February 26, 2008

**RE: REQUEST FOR STAFF APPROVAL OR, IN THE ALTERNATIVE, PETITION
FOR AMENDMENT: WALNUT ENERGY CENTER AUTHORITY WALNUT
ENERGY CENTER (02-AFC-4C) - REPLACEMENT OF BACKWASH TANK**

Figure 1 WEC Aerial of Tank Area

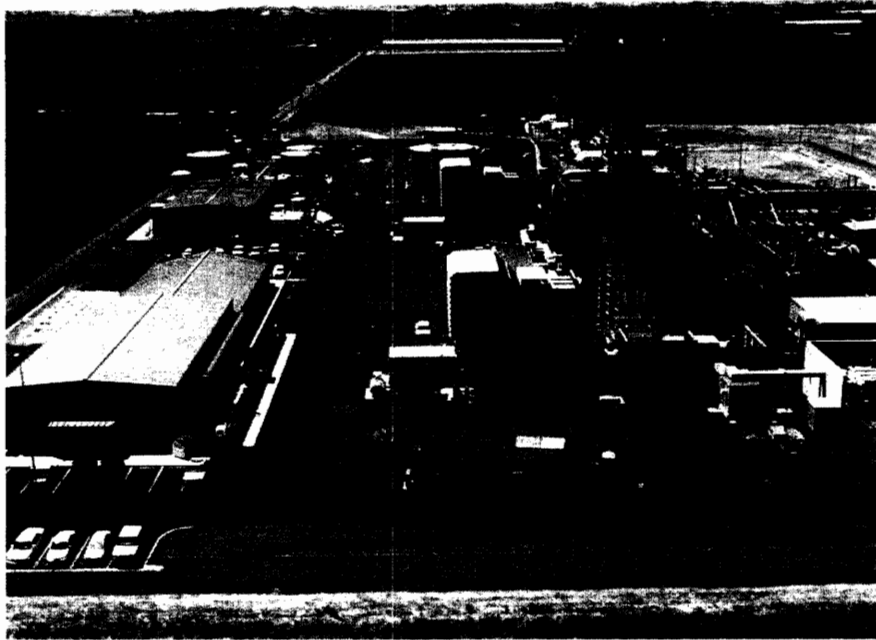
The Walnut Energy Center (WEC) was permitted with an 18,000 gallon, 12' diameter by 20' high backwash holding tank. The Walnut Energy Center Authority (WECA) would like to replace this tank with a 24,000 gallon, 12' diameter by 30' high tank. The backwash tank is part of the plant's zero liquid discharge (ZLD) system. The larger sized tank is needed to make the ZLD system operate more effectively and to address changes to the system resulting from the plant's use of recycled water.

Figures 1 and 2 represent views of the existing backwash tank in relation to the other WEC tanks. The backwash tank is outlined in red. The new 30 foot tall backwash tank will be comparable in size to the other plant tanks, which range in height from approximately 30 to 40 feet. The new tank would also be painted the same color and finish as the other tanks on the WEC site. Given the similarity in size, color, and finish the new 30 foot tank will not change the visual profile of the WEC plant.
